MONTGOMERY COUNTY PLANNING DEPARTMENT
THE MARYLAND-NATIONAL CAPITAL PARK AND PLANNING COMMISSION

MCPB
Item # 22
September 6, 2007

To: Montgomery County Planning Board
From: ICC Internal Review Team (301-495-4530) *DKH*
Date: August 24, 2007
Subject: Intercounty Connector Mandatory Referral
Planning Board Briefing #2

RECOMMENDATION: Transmit recommendation to SHA supporting revision to ICC limits of disturbance affecting parkland at the Lower Oak Springs stormwater management pond in Upper Paint Branch Stream Valley Park.

Exhibit 1. Location of proposed revisions in vicinity of Lower Oak Springs pond

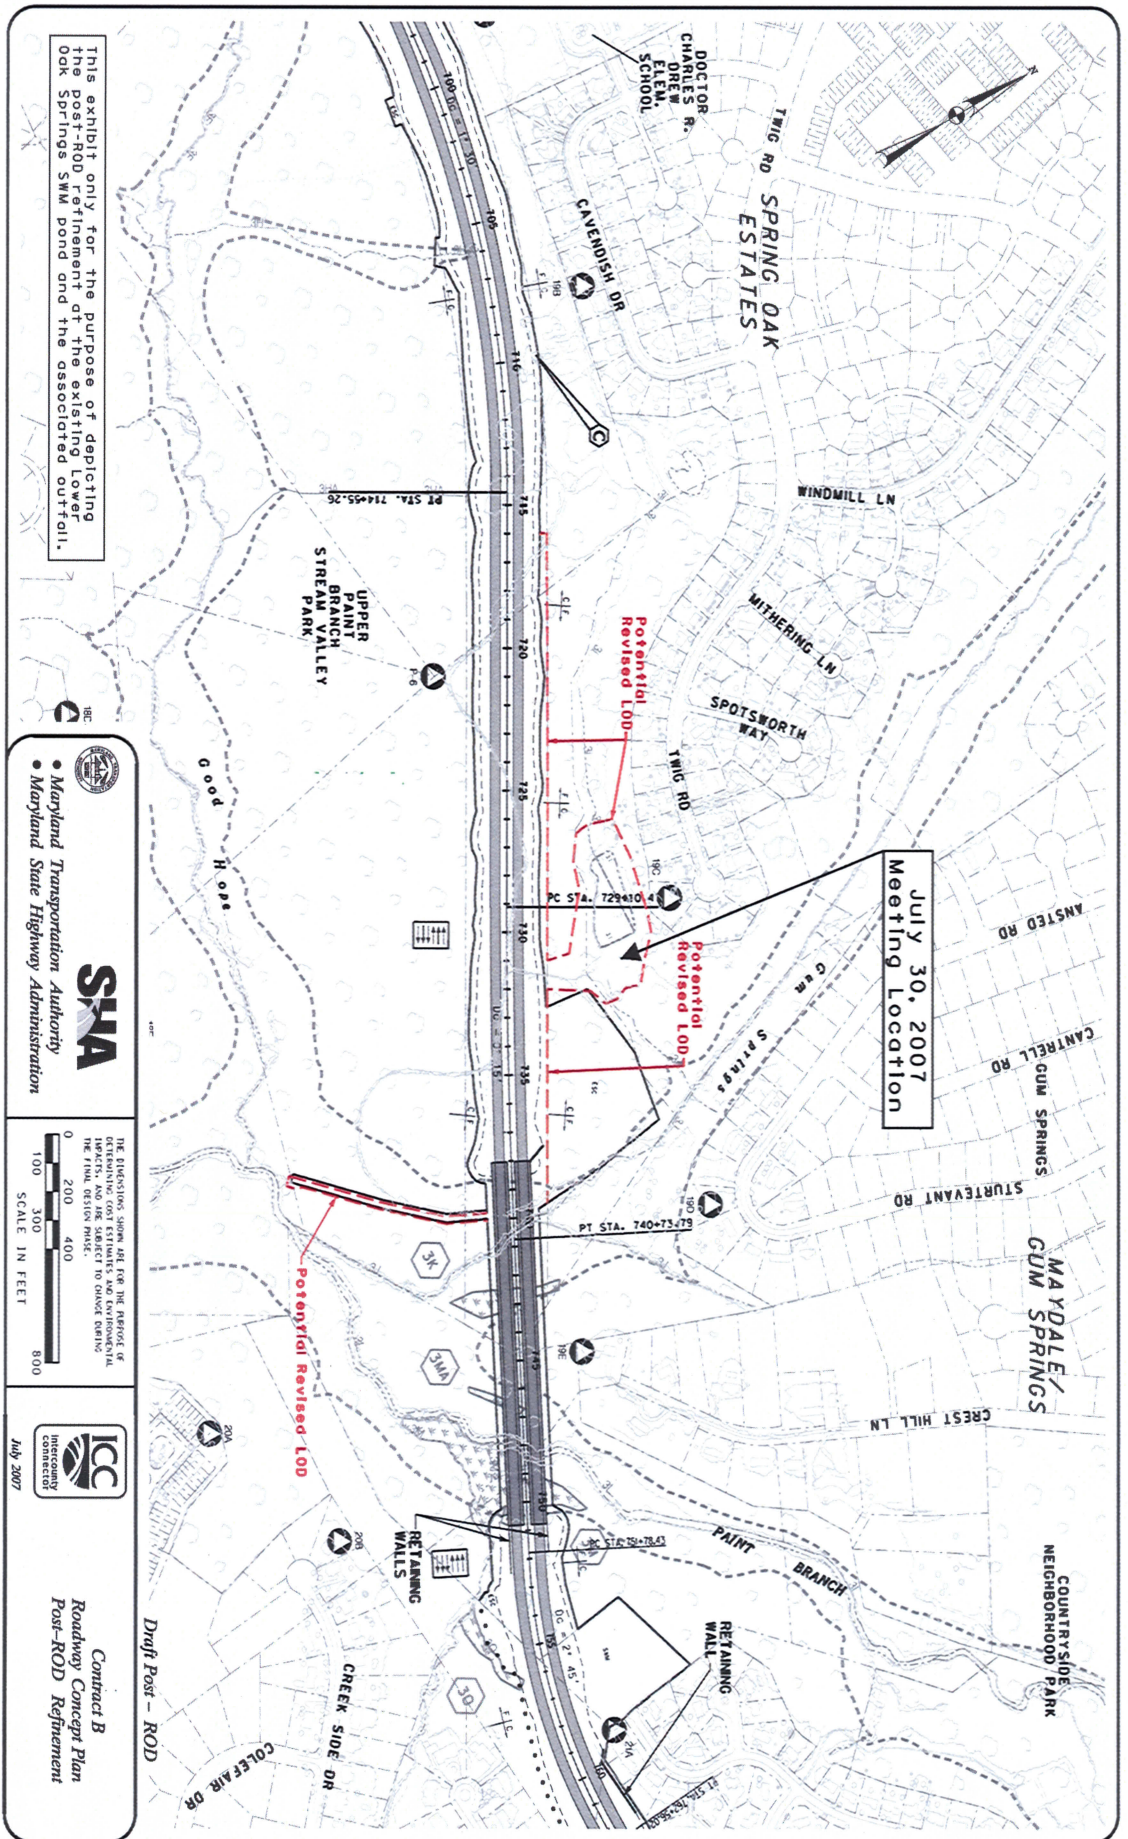
Exhibit 1 shows the Limits of Disturbance (LOD) for the ICC included in the ROD, indicated by a solid black line. The proposed revisions are shown in dashed red lines with notations of "Potential Revised LOD" in three locations:

- The westernmost revision includes extending the LOD around the existing stormwater management pond near Station 730 and adjusting the LOD to match the existing parkland boundary between Stations 715 and 730 to incorporate a future path for maintenance vehicle access to the stormwater management pond.

- The center revision includes adjustment of the LOD to match the existing parkland boundary between Stations 733 and 740, eliminating the erosion and sediment control (ESC) area shown on the map.
- The eastern revision (south of the ICC) is a slight adjustment to the outfall pipe location to allow treated outfall from the ICC stormwater management system to effectively reach the Paint Branch. This pipe will be adjacent to the existing pipe that carries treated outfall from the Lower Oak Springs stormwater management pond that was installed for the protection of the highly valued Gum Springs Tributary.

Staff recommends that the Planning Board concur with the proposed changes at the Lower Oak Springs stormwater management site. This change will result in a net reduction of 1.0 acres of parkland impact and a reduction of approximately 2.5 acres of forest impact.
